TRANS/WP.30/2004/23
30 April 2004

**CUSTOMS CONVENTION ON THE INTERNATIONAL TRANSPORT
OF GOODS UNDER COVER OF TIR CARNETS (TIR CONVENTION 1975) ^{*/}**

New Comment to Annexes 2 and 7

Submitted by the Government of the United States of America (USA) ^{/}**

Photo A

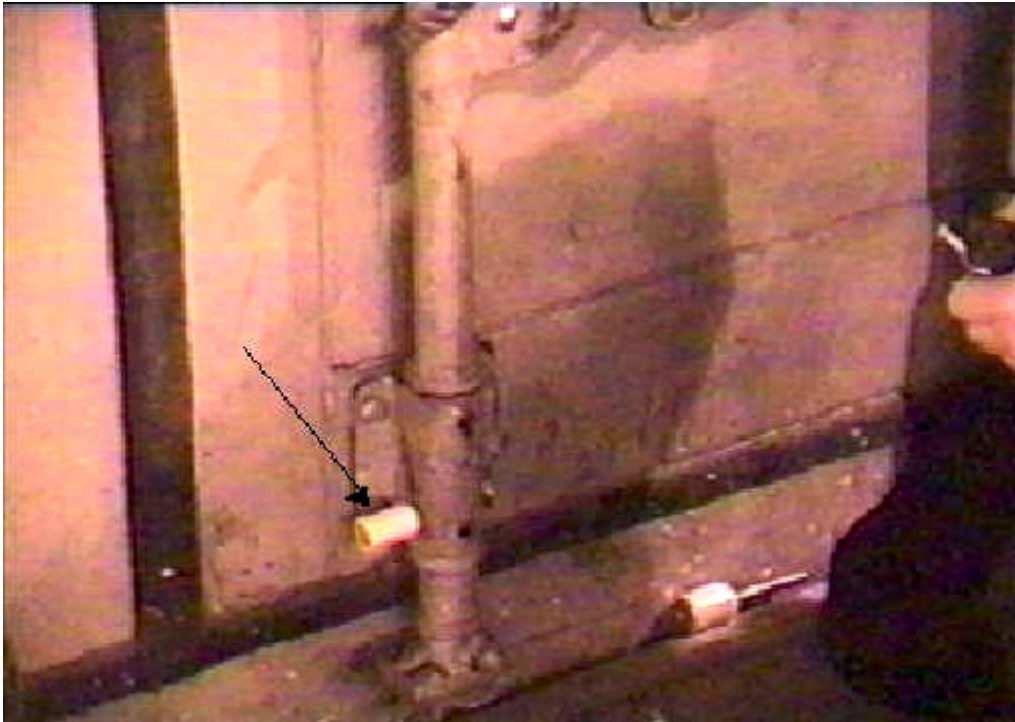
- (a) A ½ in. (1.27 cm) hole should be drilled through the vertical bar on the right-hand door of the container and through the lower plate fastening that bar to the door of the container. A mechanical or electronic seal should then be affixed through this hole, covering the rivet heads on the plate to prevent tampering. The placement of a seal in this manner will prevent opening of the container, despite any tampering with the handle area. (See photo A)*

Photo B

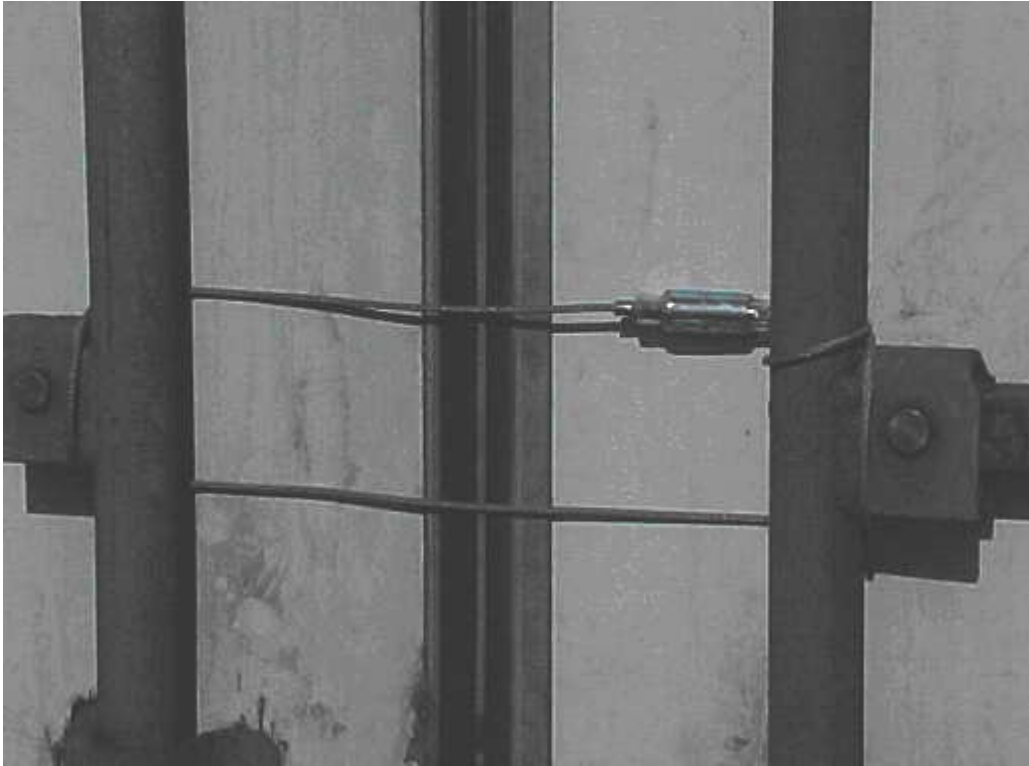
(b) Cable seals should be attached as per the manufacturer's instructions. In addition, when affixed, cable seals should be tight, with all excess cable looped, twisted or otherwise secured to prevent them from moving easily. (See photos B and C)
